# Land at Foxhole Farm, Bolney: West Sussex County Council Response Note

Ref: DS/SGa/ITB16634-021A  
Date: 2 July 2025

1.1.2 West Sussex County Council, in its capacity as local highway authority, has provided a response to the application dated 12<sup>th</sup> June 2025, requesting further information be provided.

DRAWN:	CHECKED:	APPROVED:
JB	ML	JCB
PROJECT No:	SCALE @ A2:	DATE:
ITB16634	1:1000	07.02.22
DRAWING No:	REV:	
ITB16634-GA-005	H

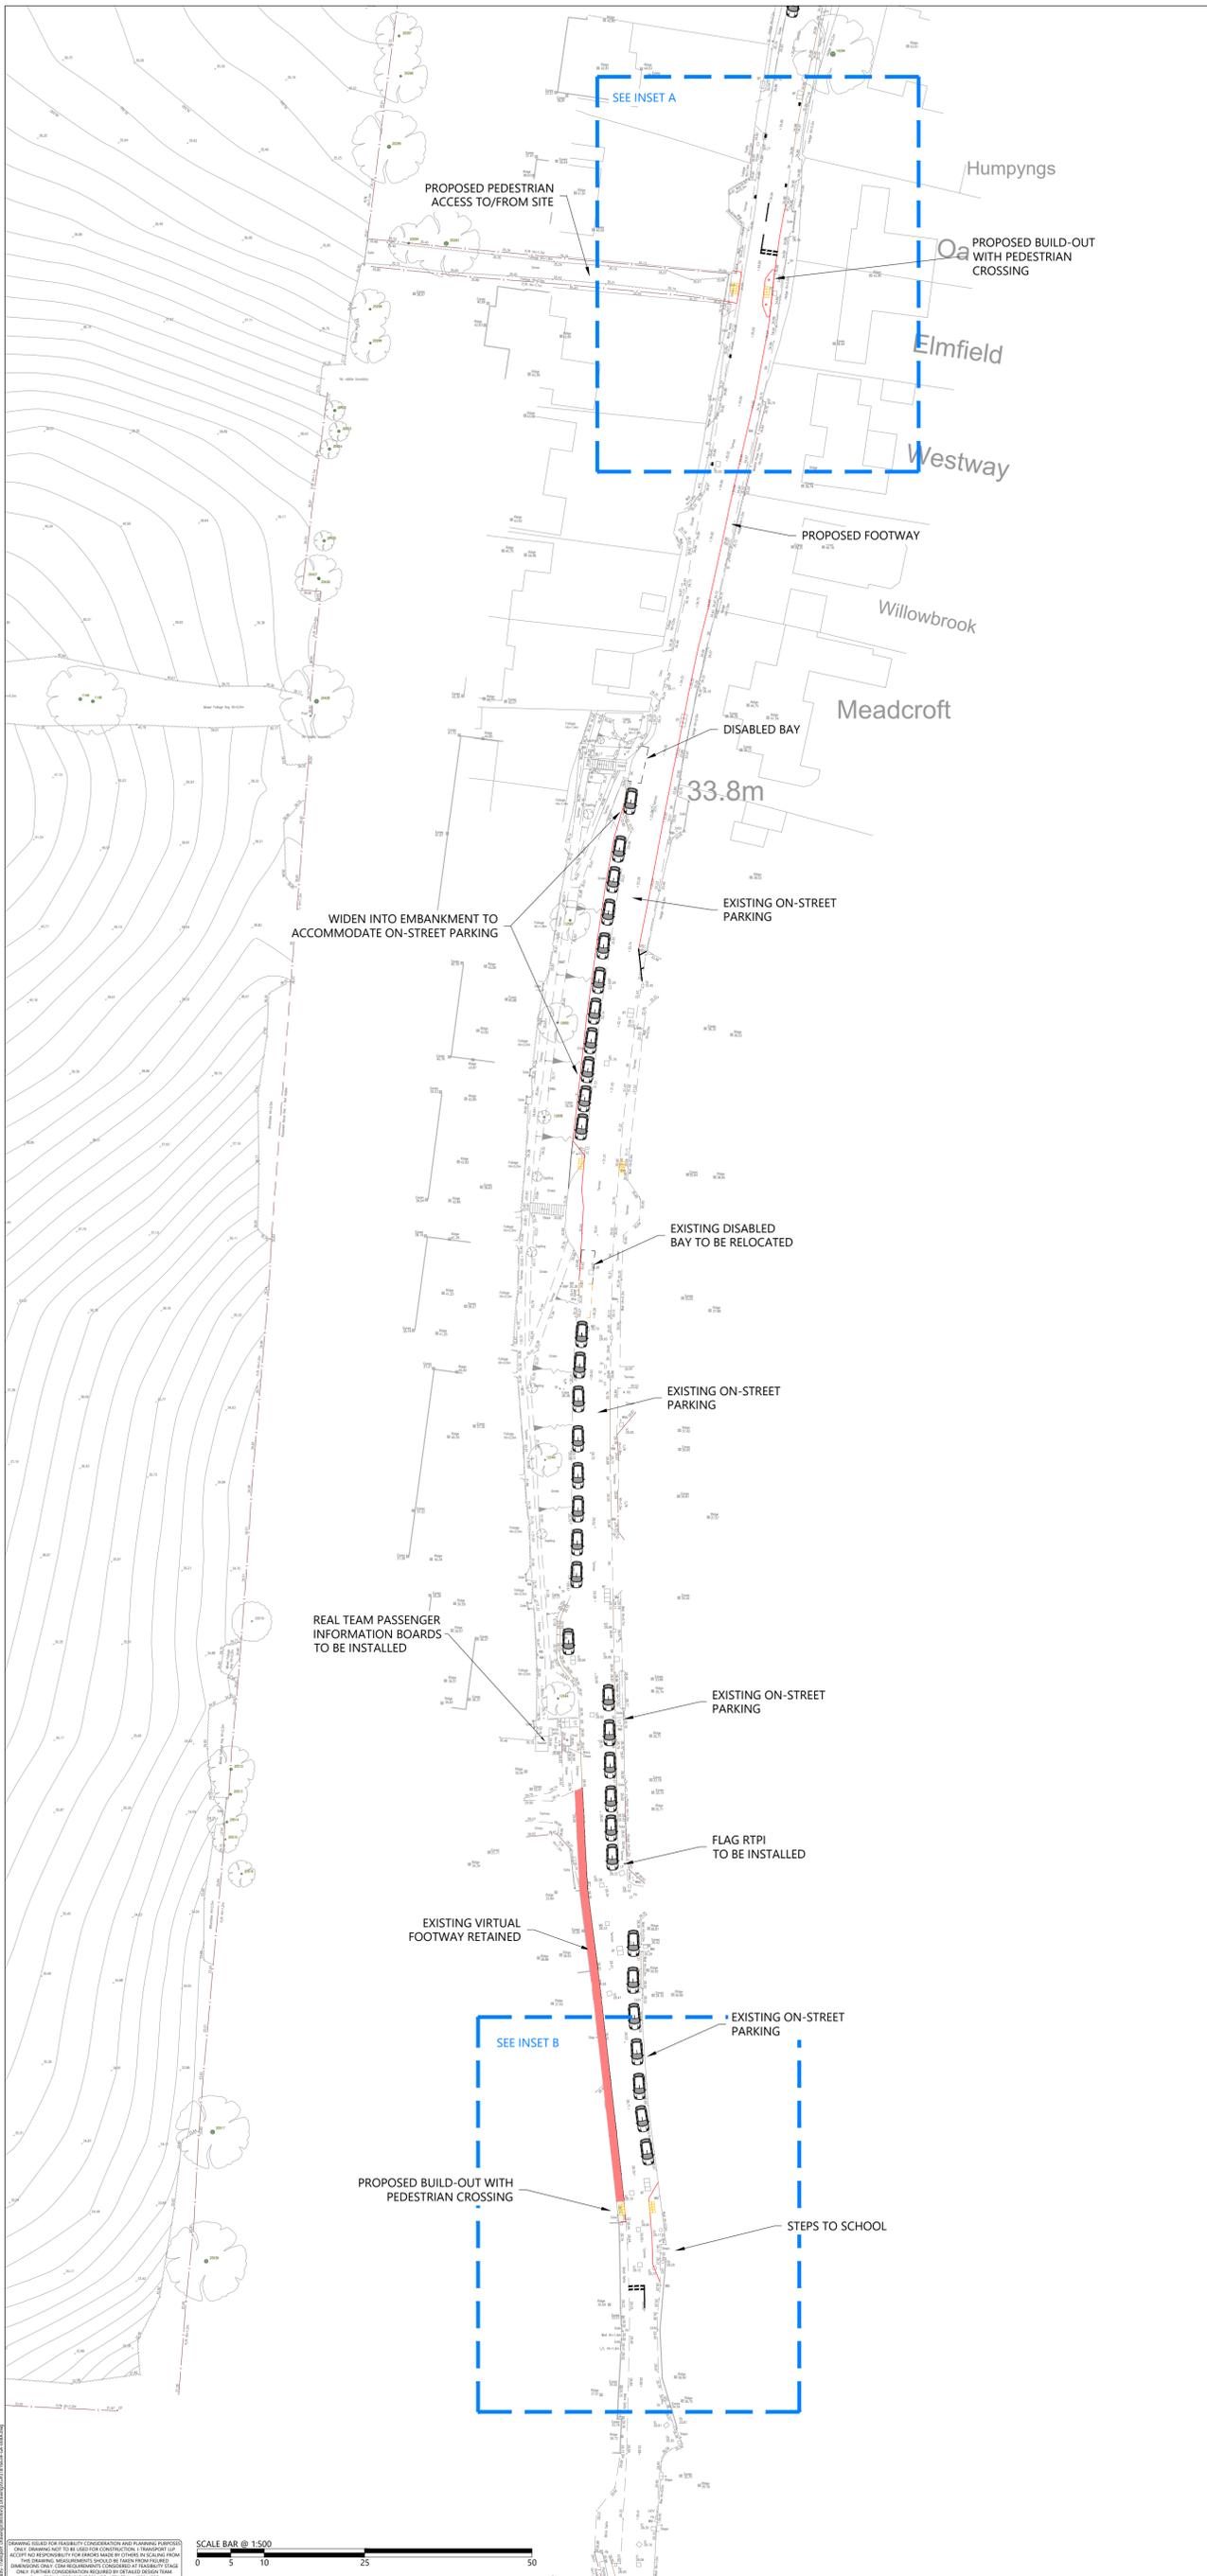
The proposed RED high friction surface proposed is noted, we would recommend that BUFF colouring is employed as it has a more sustained visual impact. However, the proposed red surfacing is accepted where used as eyebrows to highlight terminal/roundel locations.

<b>A.1</b>	<b>LOCAL ALIGNMENT</b>
<b>A.1.1</b>	<b>PROBLEM</b>
<b>Location:</b>	A272 Cowfold Road
<b>Summary:</b>	Proposed eastbound entry taper does not allow for a smooth path
<b>Acc Type:</b>	Loss of control type collisions
<p>The A272 Cowfold Road is a single carriageway two-way road which is subject to a 40mph speed limit as it passes through the village of Bolney, although 85<sup>th</sup> percentile speeds of up to 52.1mph are observed. The proposals that are subject to this Stage 1 Road Safety Audit include the provision of a priority access off the northern side of the carriageway and a right turn lane through the widening of the existing carriageway to the north only. As part of the works, a refuge island is to be provided within the western taper of the right turn lane. Measurements have been taken off the scheme drawing provided with the Audit Brief and it appears that the eastbound entry taper associated with the proposed 3 metre wide right turn lane, measures circa 46 metres. It can therefore be determined that the taper is to be set at 1 in 15. The Audit Team have concerns that a taper of 1 in 15 will not provide a smooth alignment for eastbound traffic entering the through lanes and on approach to the refuge island which could lead to collisions with the island and loss of control type collisions.</p>

<b>RECOMMENDATION:</b>	
<p>It is recommended that the road centreline and inside corner radii are increased to mimic the existing.</p>	
<b>Location Plan:</b>

<b>RECOMMENDATION:</b>	
<p>It is recommended that the existing sign is relocated / raised to ensure adequate visibility for all drivers.</p>	
<b>Location Plan:</b>

It is recommended that the tactile warning is increased to a depth of 1200mm.

2.1.3      Drawing No. **ITB16634-GA-005H**, submitted with the application, reflects all updates made a result of the Stage 1 RSA. The GG119 Audit Log, including responses from WSCC and agreed Audit actions, is attached at **Appendix B** and will be forwarded to WSCC in Word format to enable completion of the document.

2.1.4      The red coloured surfacing previously identified has been replaced with buff surfacing as requested by WSCC.

REV	DATE	BY	DESCRIPTION	CHK	APP	PROJECT:	
H	24.06.25	TA	HIGH FRICTION SURFACE COLOUR HAS BEEN AMENDED	DS	DS	PROJECT: LAND WEST OF BOLNEY	
G	28.10.24	JB	VISIBILITY SPLAY UPDATED	DS	DS		
F	07.08.23	JB	VISIBILITY SPLAY UPDATED	ML	DS		
E	06.08.23	JB	DESIGN UPDATED TO TOPO SURVEY	ML	DS		
D	10.08.23	JB	DRIVEWAYS AND SIGNAL HEADS ADDED	ML	DS		
C	06.06.23	JB	DRAWING UPDATES FOLLOWING RSA	ML	DS		
STATUS:							CLIENT: WATES DEVELOPMENTS
FOR INFORMATION

<p><b>DESIGN ORGANISATION RESPONSE</b> provided by i-Transport on the 5th June 2023 following formal issue of this Stage 1 Road Safety Audit on the 9<sup>th</sup> May 2023.</p>	
<p>Agreed – the eastbound entry taper is set at 1 in 20 in accordance with the 40mph speed limit. This can be determined from the level of deviation of the road centreline which equates to 2.27 metres for eastbound traffic. The scheme proposals enhance the existing traffic calming features along the A272 Cowfold Road through Bolney which will highlight the 40mph speed limit and assist in reducing 85<sup>th</sup> percentile speeds observed.</p>	
<b>A.1.2</b>	<b>PROBLEM</b>
<b>Location:</b>	A272 Cowfold Road
<b>Summary:</b>	Proposed eastbound exit from the right turn lane junction does not allow for a smooth path
<b>Acc Type:</b>	Loss of control and sideswipe type collisions
<p>The A272 Cowfold Road is a single carriageway two-way road which is subject to a 40mph speed limit as it passes through the village of Bolney. To the east of the village, the A272 Cowfold Road carriageway follows an ‘S’ bend formed with circa 50° corners with a road centreline radius of circa 108 metres. The proposals that are subject to this Stage 1 Road Safety Audit includes the provision of a right turn lane along the A272 Cowfold Road in the centre of Bolney that is to be provided through the widening of the existing carriageway to the north only. Measurements taken off the scheme drawing indicate that the eastbound nearside channel line is to transition back to the existing carriageway with a corner radius of 57 metres and road centreline radius of 73 metre. The Audit Team have concerns that whilst the existing centreline radius does not conform to standards and that the proposed centreline radius of 73 metres extends for a minimal distance, the proposals do not allow for a smooth alignment which could lead to collisions with the island and loss of control or sideswipe type collisions with opposing traffic.</p>

<p>Agreed - the inside corner radii has been amended to 100m and the centreline is provided in accordance with the relevant design standards.</p>	
<b>A.2</b>	<b>GENERAL</b>
	<i>No Road Safety Concerns in GENERAL have been raised at this stage</i>
<b>A.3</b>	<b>JUNCTIONS</b>
<b>A.3.1</b>	<b>PROBLEM</b>
<b>Location:</b>	A272 Cowfold Road
<b>Summary:</b>	An existing crossroads ahead advance direction sign may limit visibility
<b>Acc Type:</b>	Vehicle side impact collisions
<p>The A272 Cowfold Road in proximity of the proposal, is subject to a 40mph speed limit and accommodates directional signage within the verge. The proposals that are subject to this Stage 1 Road Safety Audit include the provision of a priority access off the northern side of the carriageway as well as the widening of the carriageway to the north in order to provide a right turn lane and relocation of an existing signal-controlled crossing. The scheme drawing illustrates that visibility splays in accordance with the speed limit of the road are achievable, however, the Audit Team have concerns that an existing crossroads direction sign will restrict visibility for drivers of large vehicles particularly heavy goods vehicles. Restricted visibility from a priority access could lead to drivers attempting to manoeuvre when it is not safe to do so and side or rear impact collisions.</p>

Agree – The scheme drawing has been updated to identify that 3 rows of tactile paving, totalling 1200mm, will be provided.
